Notice of Modification

Section 75W of the *Environmental Planning and Assessment Act 1979*

The project approval (08_0101) granted by the Minister for Planning on 26 November 2010 for the Integra Underground Project.

Figure 4: Approved Middle Liddell Seam - Longwall Panels (330 m width for Longwalls 15 – 19)

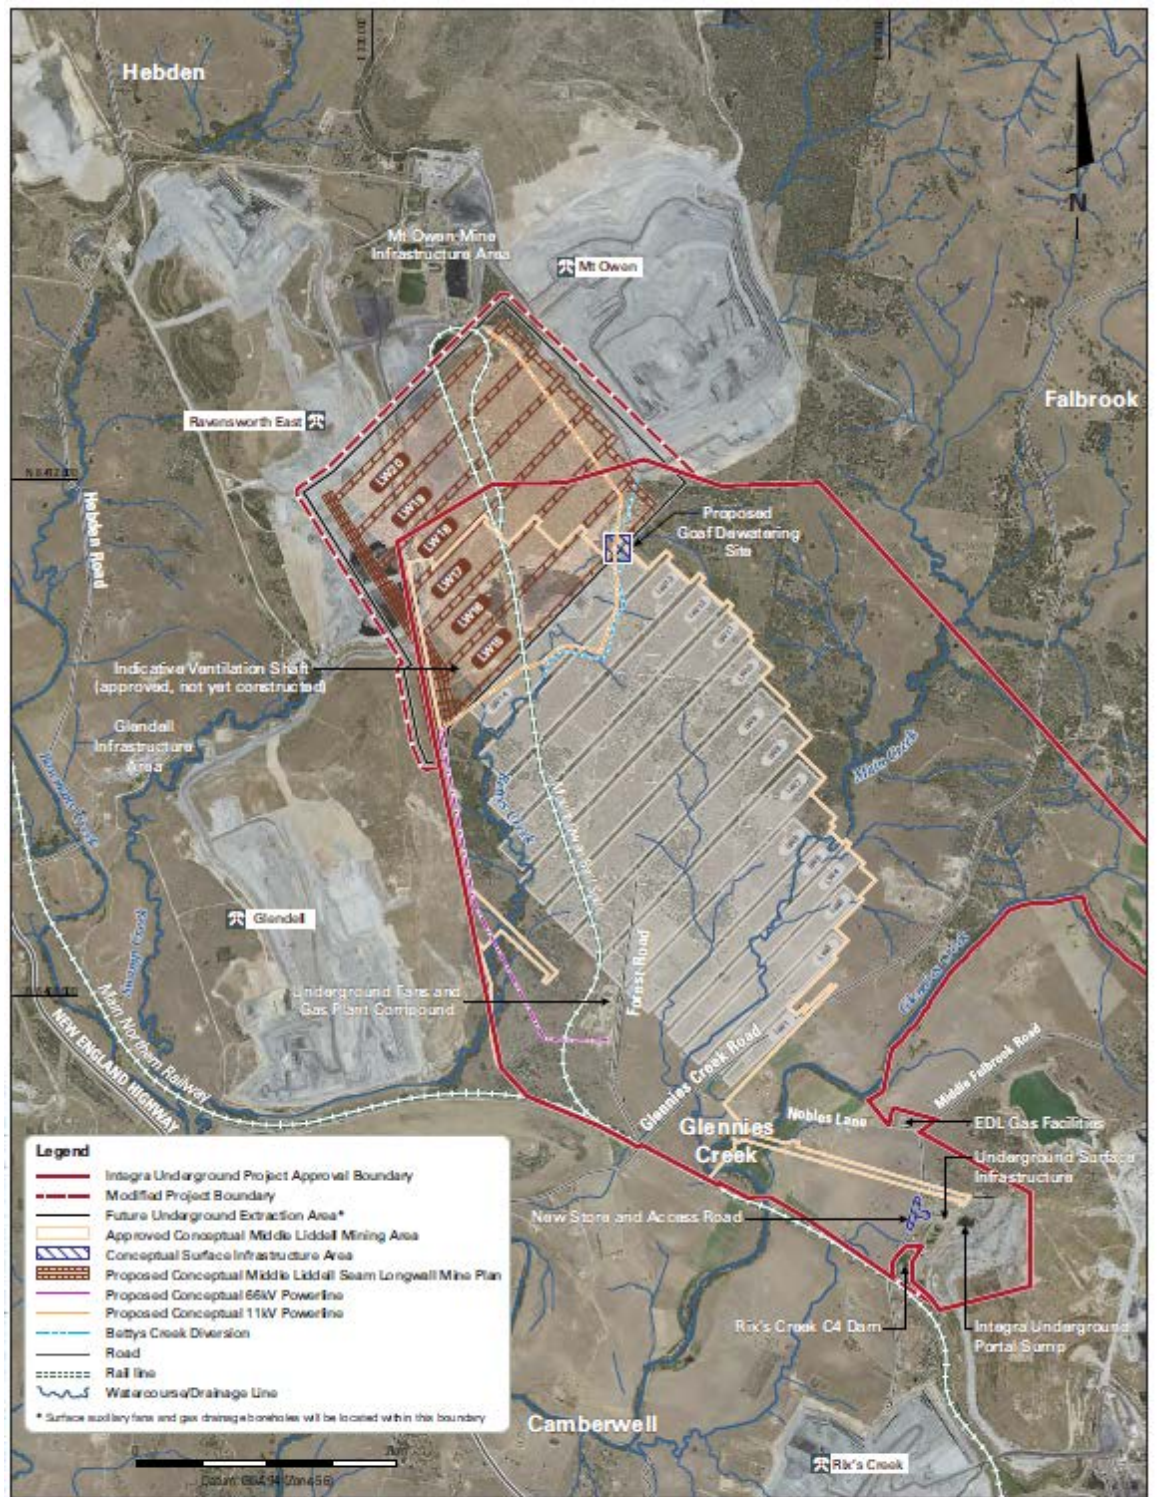
- 11. Delete Figure 2 in Appendix 3.
- 12. In Appendix 3, following Figure 3, insert the following:
